Access Assessment Report

90 Cambewarra Road, Bomaderry

Reference No: 114572-Access-r02

Date: 28 June 2022

Figure: Principal Pedestrian entry to be accessible.

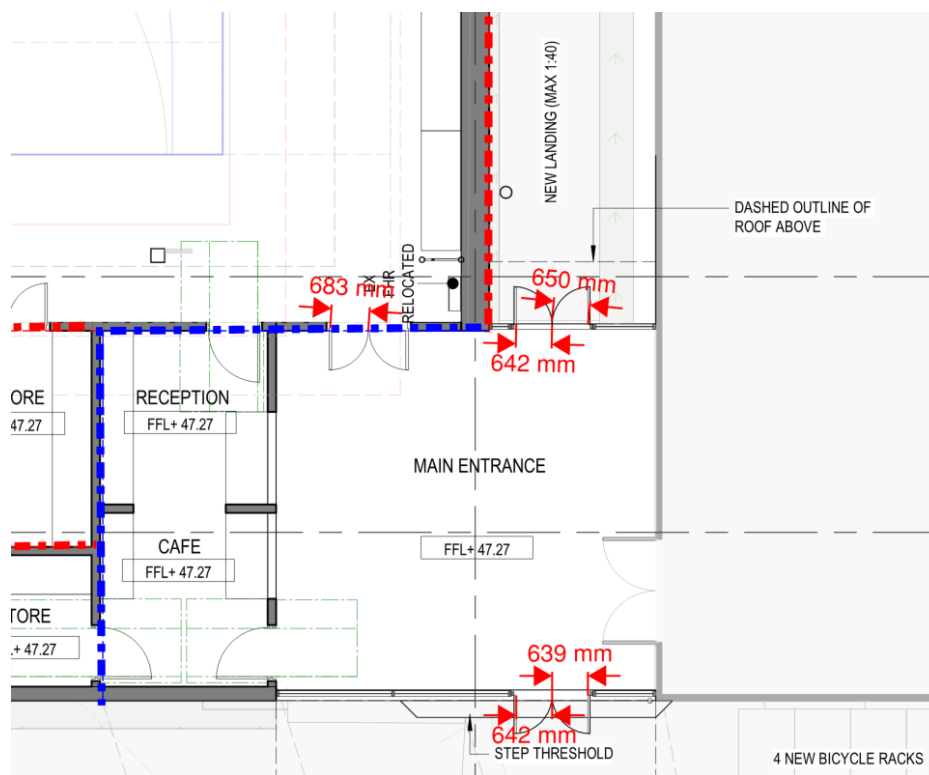
The two entry points to the building are required to be accessible whereby they are located greater than 50m apart. This will require compliant door hardware and/or push-button access in accordance with Clause D2.21 and AS1428.1-2009 and a minimum clear door leaf opening achieving 850mm.

Figure: Stair in accessway linking courts 5 & 6 to incorporate accessible features.

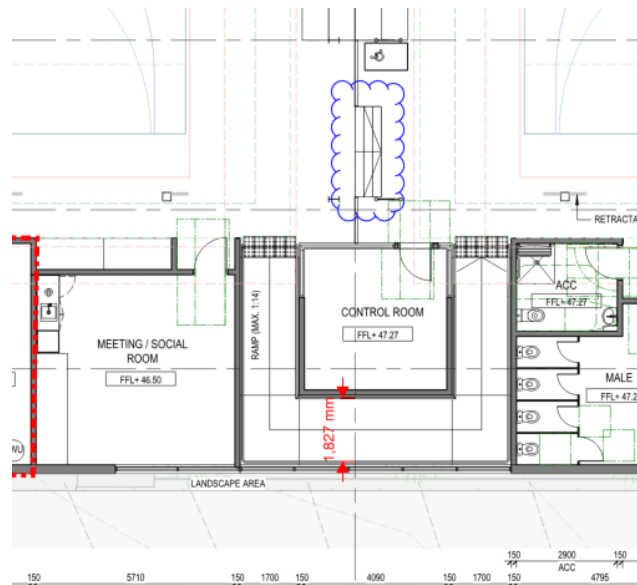
All accessible stairways are to incorporate the following accessible features:

Stair Provisions – Each access stair shall incorporate the following design provisions:

- Tactile Ground Surface Indicators (TGSIs) are to be provided at the landings to every stair. TGSIs are to comply with BCA D3.8 and AS1428.4.1-2009 requirements; and
- Handrail provisions complying with Clauses BCA D3.3, and 11 & 12 of AS1428.1-2009; and
- Non-slip nosing strips with appropriate luminance contrast in accordance with BCA D2.14 and AS1428.1-2009; and
- Opaque (solid) risers.
